# PATHFINDER

Ref: Source Material License No. SUA-442, Docket No. 40-6622

## **Discussion of Changes in the ACL Application.**

<b>PATHFINDER</b> PATHFINDER MINES CORPORATION SHIRLEY BASIN, WYOMING T28N, R28W		
FIGURE 13-9. RADIUM-226 + RADIUM-228 ACTIVITY FOR THE SURFICIAL AQUIFER, 1999		
DRAWN BY: TGM	DATE: 6-2001	SCALE: 1"=700'
		FIG13_9.DWG
REVIS. NO.:	HYDRO-ENGINEERING, L.L.C.

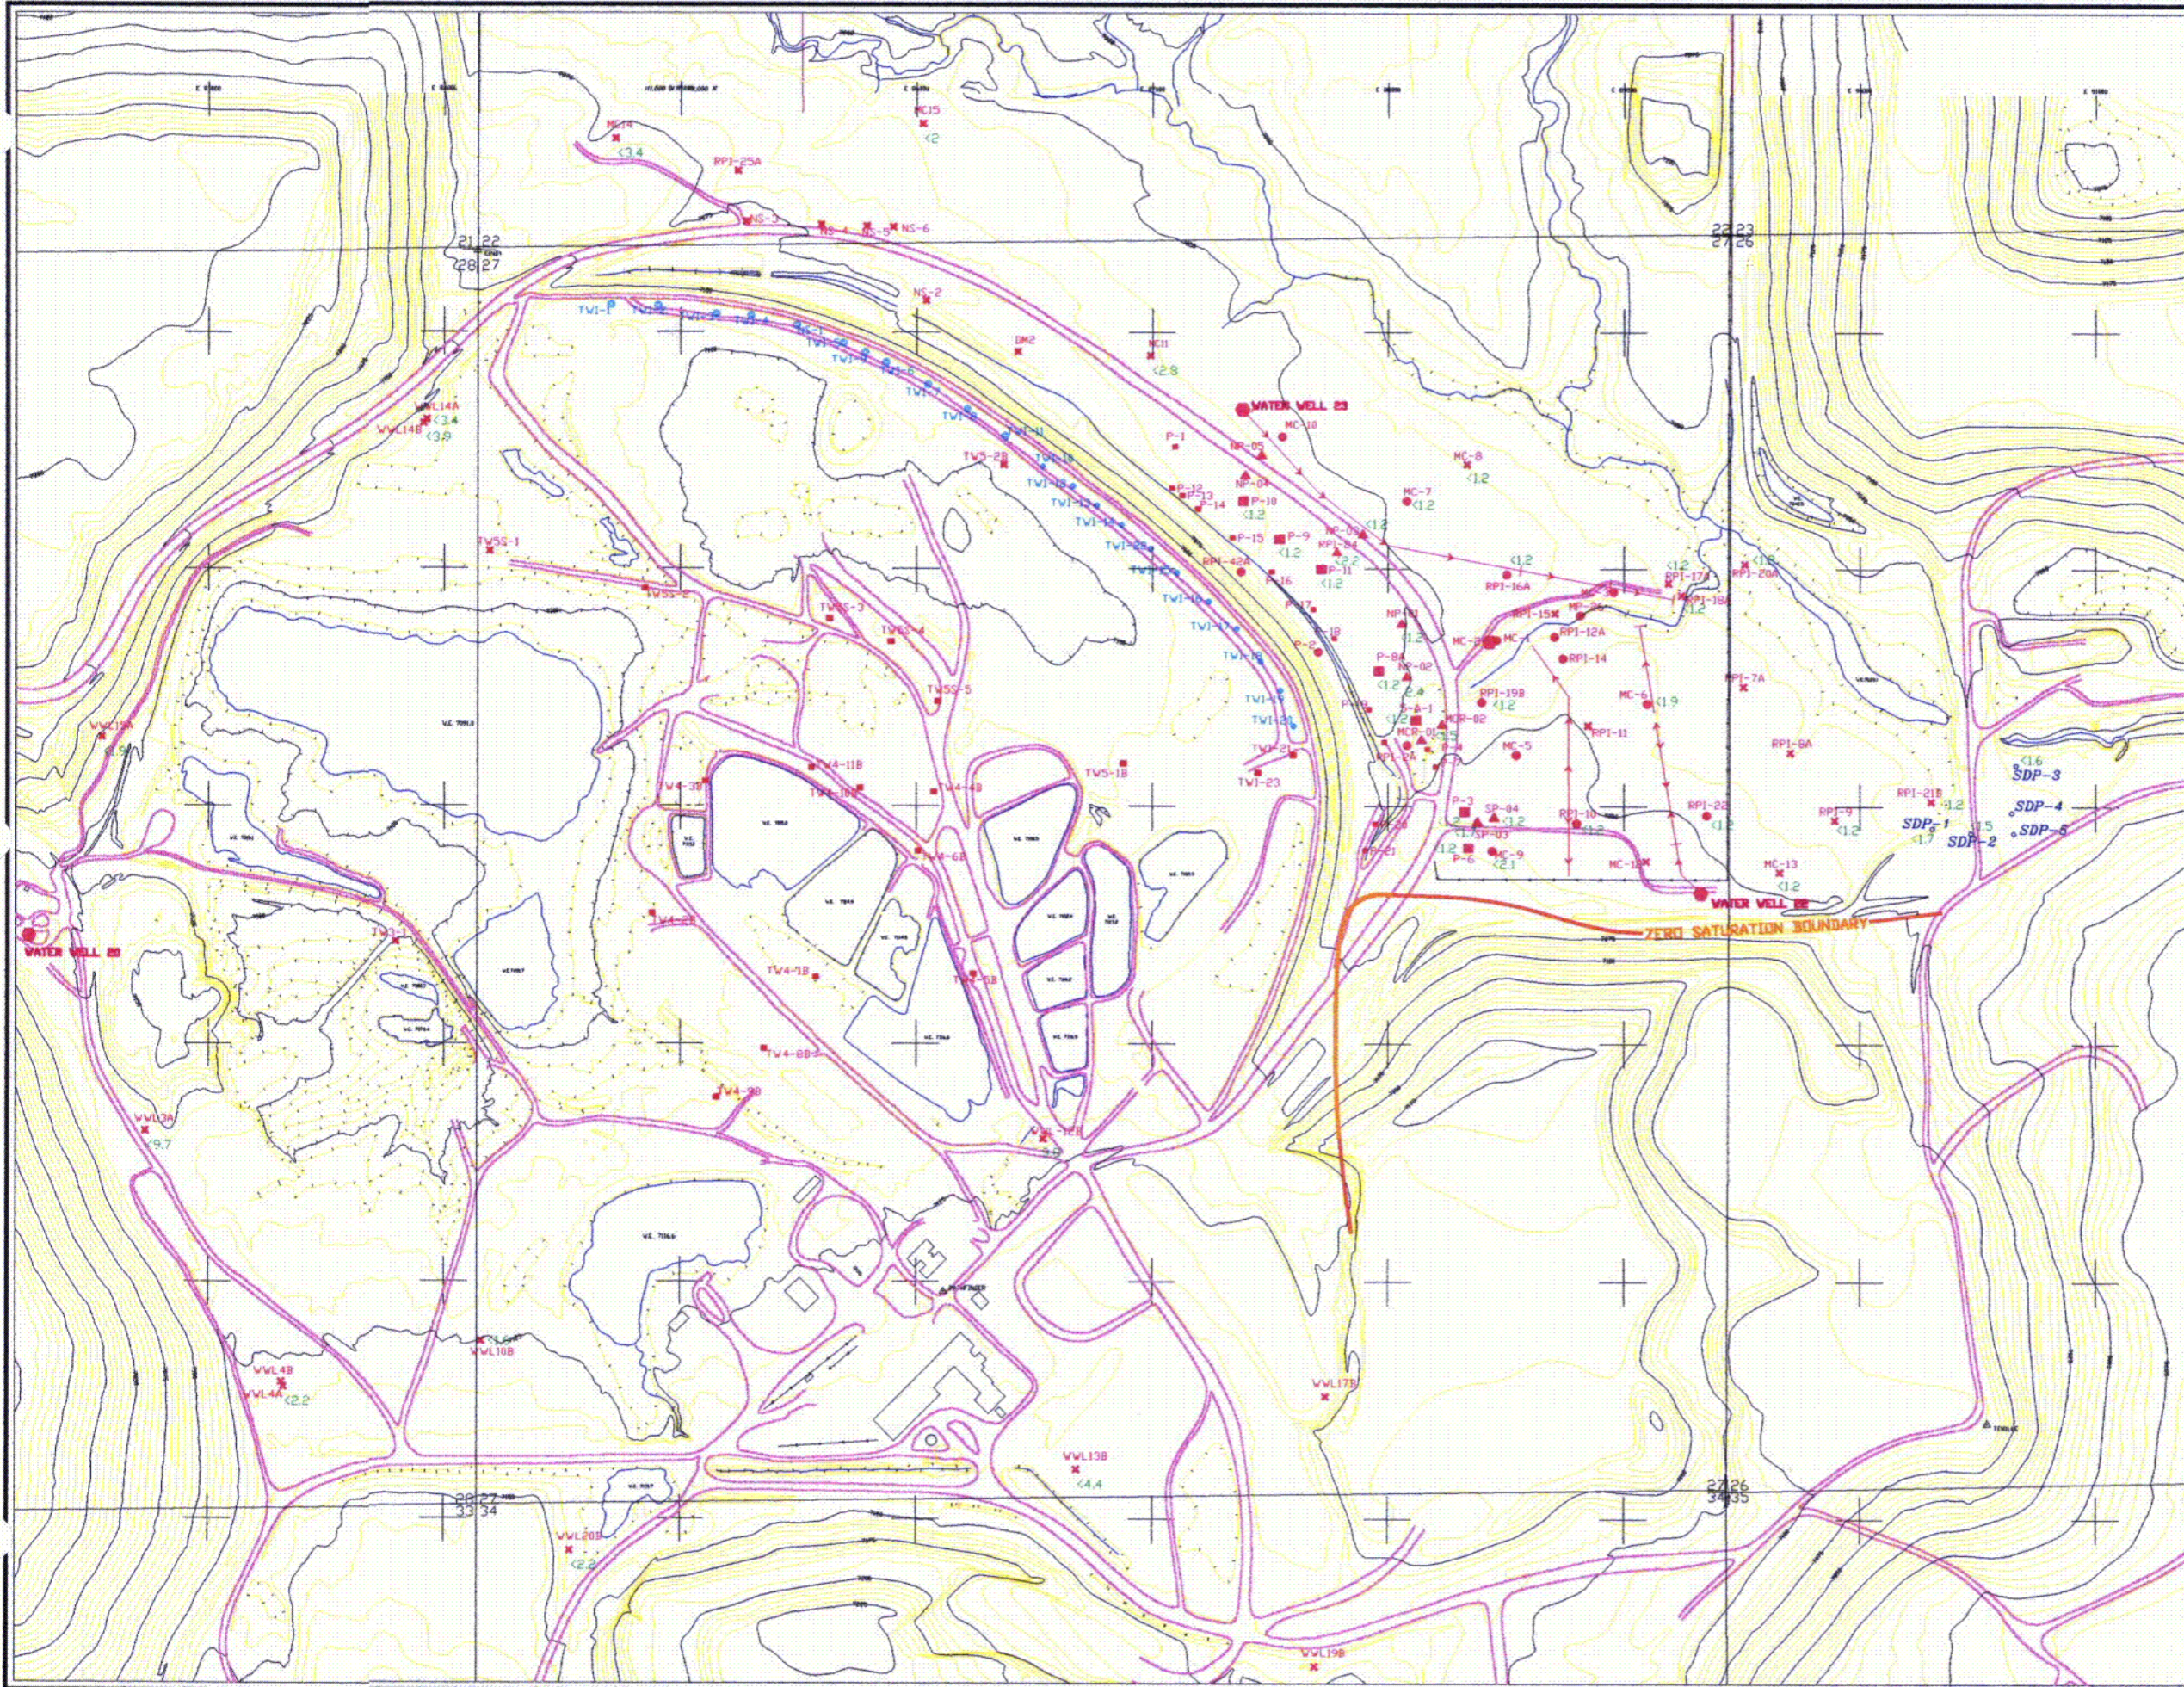
**Comment 2: Other hazardous constituents which exceed the site standards.**

**Discussion:** Like selenium, radium-226 + radium-228 has been added as an ACL constituent. In section 1.3.6.1 of the revised document, a detailed discussion of additional constituents is included. Also, the recent annual Corrective Action Report (referenced in the ACL document) included mapping of site standard constituents. This annual report also includes water quality tabulations for the constituents. This information was used in considering additional constituents for ACL's.

Figure 2.2-7. Projected Maximum Uranium Concentration Along Spring Creek

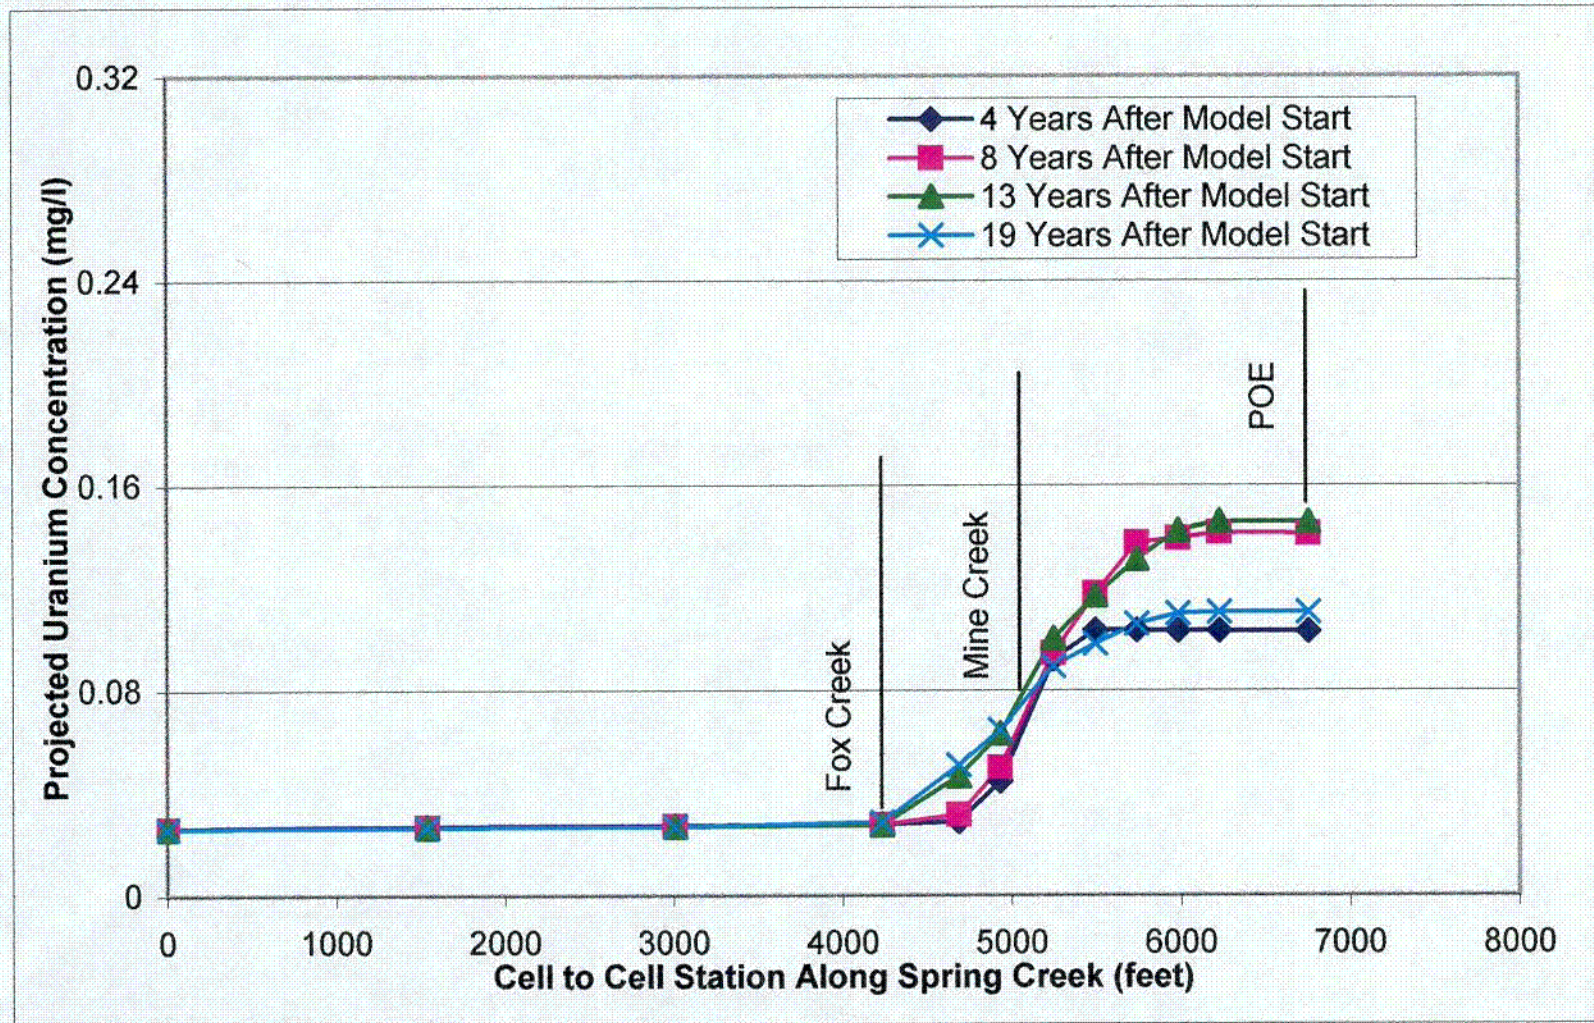
**Comment 10: POE location.**

**Discussion:** As mentioned in the response to comment 5, the POE and 2 other points along Spring Creek are included in the monitoring program. Additionally, an analysis of the selection of the POE and the progressive loading of Spring Creek is included in Section 2.2.2.4.

The changes in uranium concentration for the four periods in Figure 2.2-7 illustrate the accumulation of seepage impacts while moving downstream on Spring Creek. The next to last data point (approximately station 6230) is located just upstream of the haul road crossing of Spring Creek. There is virtually no change in concentration between this point and the POE for the four time periods. Upstream of this point there is a measurable increase in concentration while moving downstream. Figure 2.2-8 illustrates the same accumulation of seepage impacts for TDS concentration. The accumulation leads to the observation that there is no measurable change in concentrations between the haul road crossing and the current POE location. The planned POE location is therefore appropriate and the POE could possibly be moved upstream to the haul road crossing with no discernable change in results. However, further Spring Creek sampling upstream of the haul road crossing is predicted to yield concentrations that are equal to or less than the concentration at the current POE. Thus, the single planned POE is appropriate.
